Our Ref: 27594-062-01
Council Ref: AP2024/013
QA: es

RESPONSE TO INFORMATION REQUEST (REFERRAL ENTITIES) – AP2024/013
Development Permit for Reconfiguring a Lot – Boundary Realignment (8 Lots into 4 Lots) combined with Material Change of Use for Warehouses in the Townsville State Development Area (SDA)

PROJECT NAME:
TOWNSVILLE NEW WAREHOUSE AND OFFICES

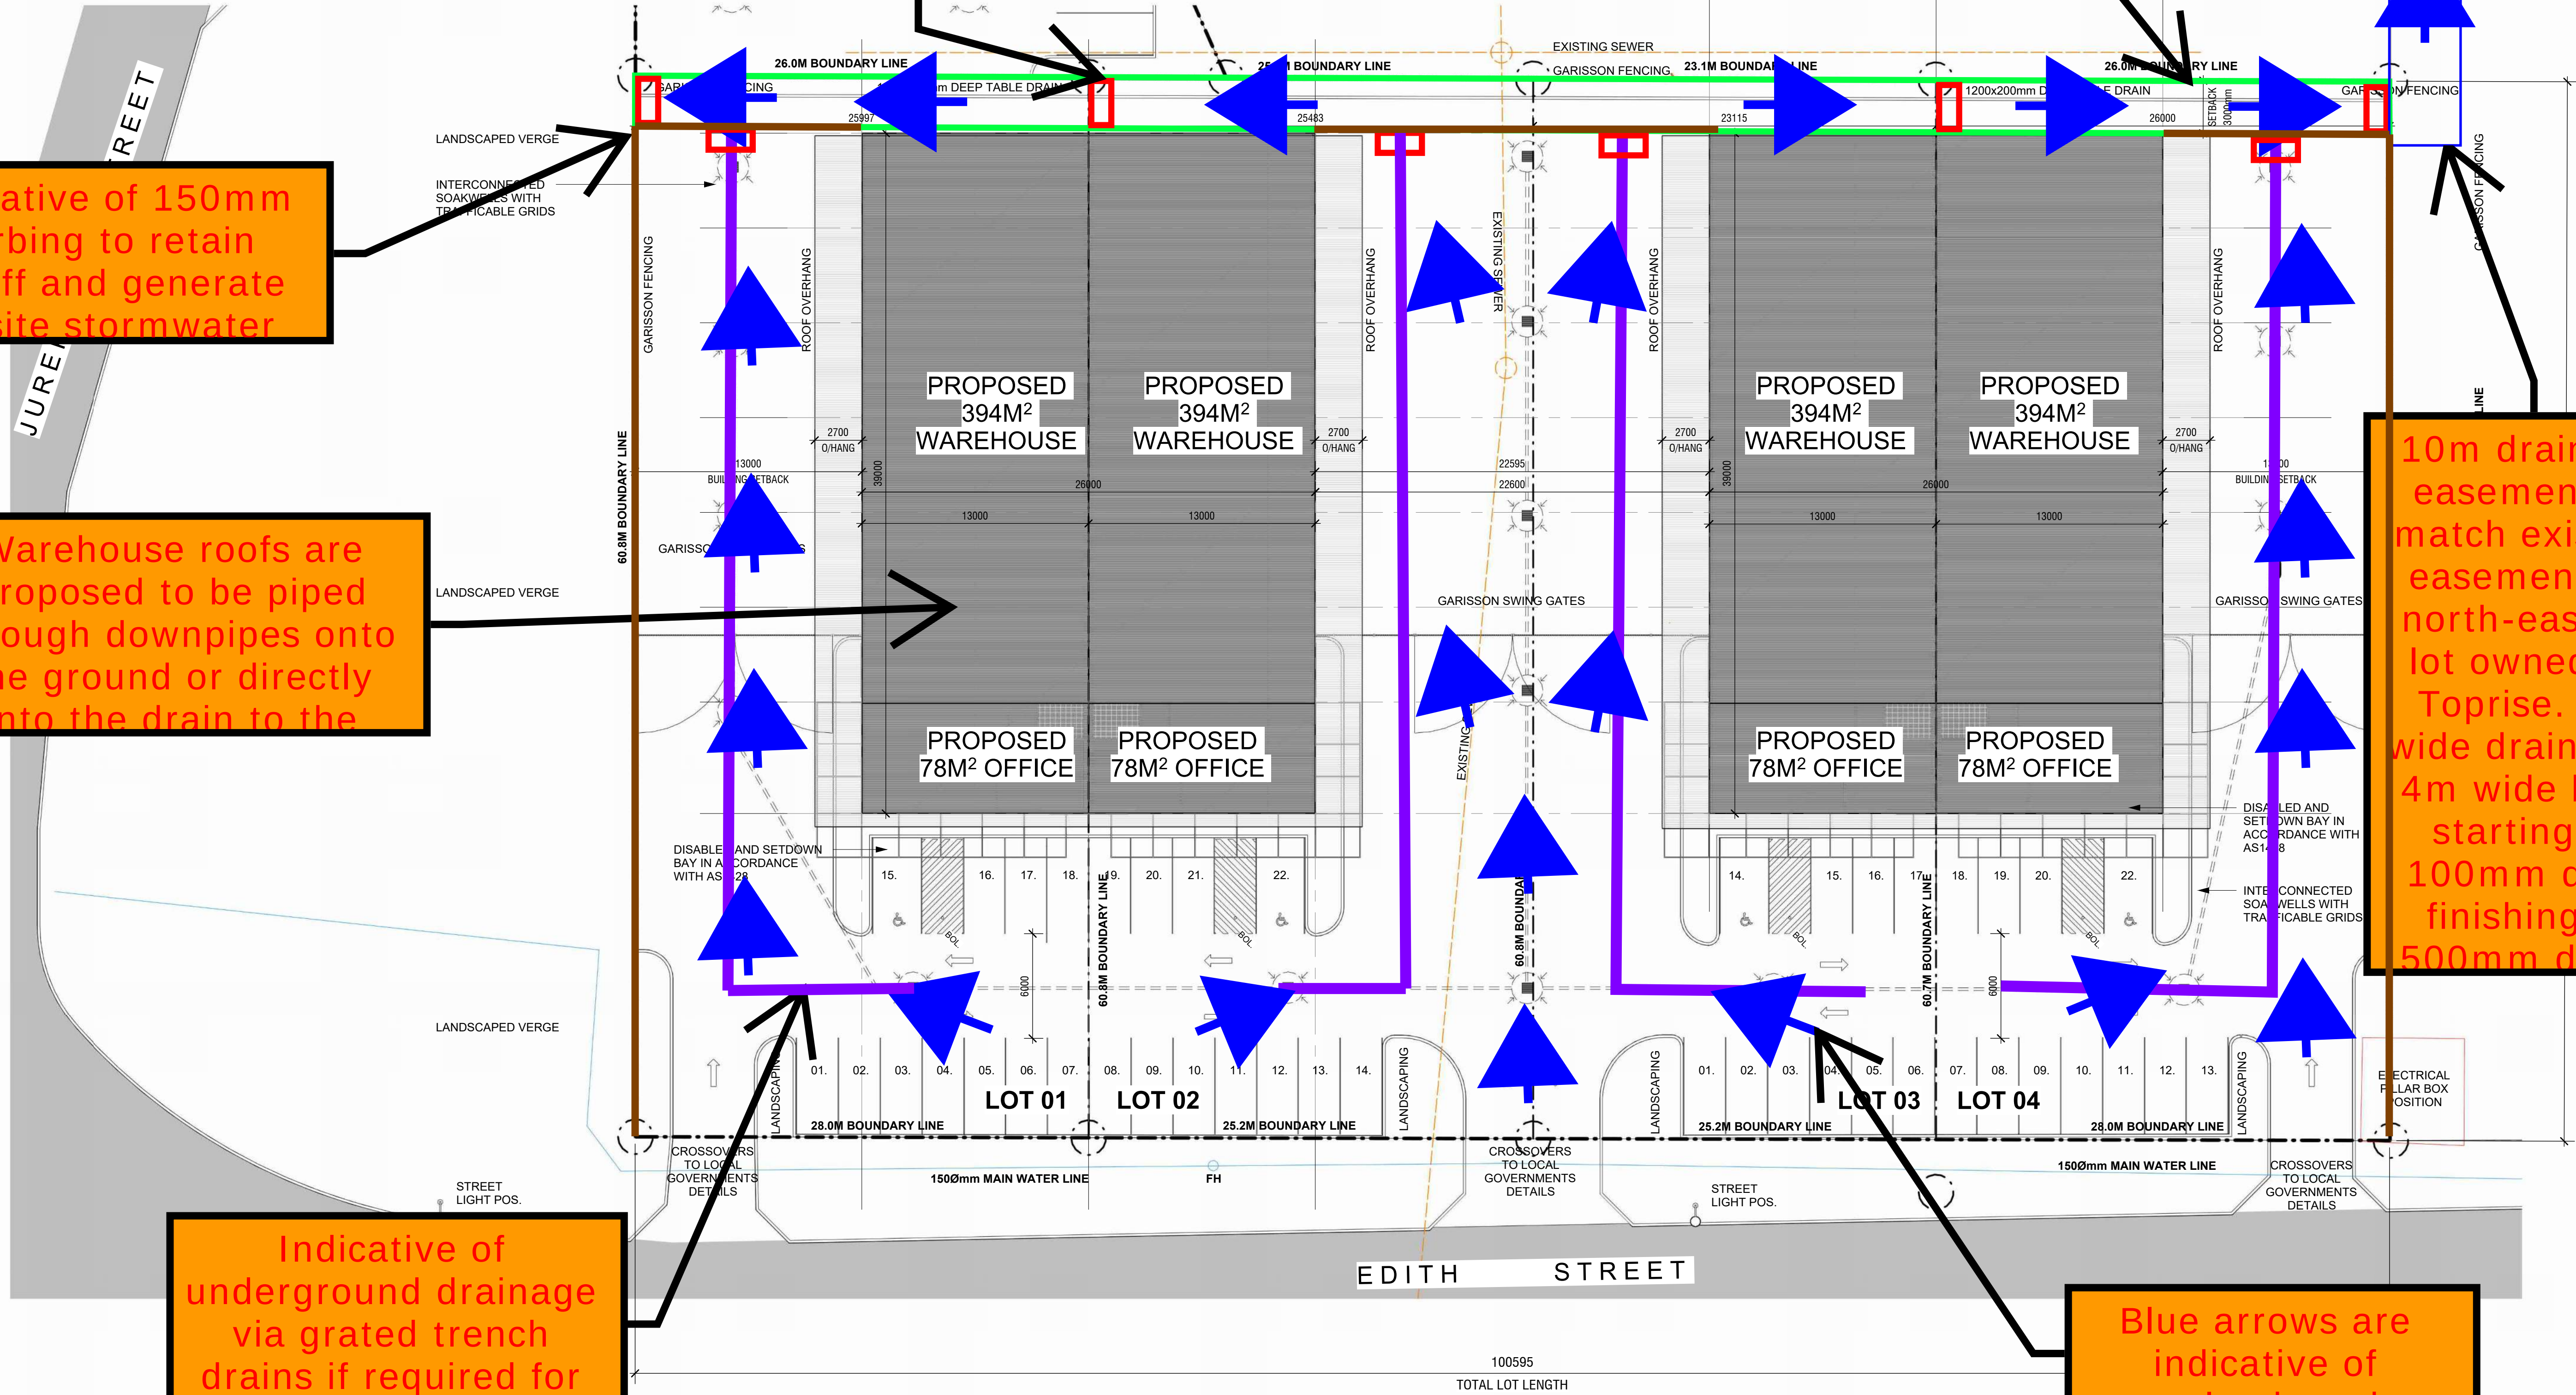
- the drawings in Attachment C (Redline Concept Mark-ups prepared by NCE) do not show any levels (internal or external), so it is unclear whether a free draining detention system is achievable, particularly given the flat grades within and external to the site and the absence of any external piped drainage.
- it is not clear where water discharged from the site is conveyed. It appears that flows leaving the site from the proposed lawful point of discharge would overtop Jurekey Street before crossing the rail corridor at a culvert near the Racecourse Road Bridge.

The proponent is requested to provide a revised Site Based Stormwater Management Plan that demonstrates compliance with PO12 – PO14 and PO16 of State Code 2: Development in a Railway, of the State Development Assessment Provisions. The updated report should address the above

The redline concept markup provided within the Site Based Stormwater Management Plan report shows the mitigation measures which have been modelled to generated the above ponding indicated on site. The detailed design is to be implemented strictly in accordance with the redline concept design.

Indicative of weir walls with low flow pipes or v-cut flow constrictions to generate storage through drain and carpark. Equivalent low flow opening = DN225 pipe for internal weirs and 2/DN225 for final weirs to drain outlets.

1.2m wide drain at 0.3m deep and 1 in 4 batters to back of lot for drainage and storage. Potential to be grassed to add to treatment

Indicative of 150mm kerbing to retain runoff and generate onsite stormwater
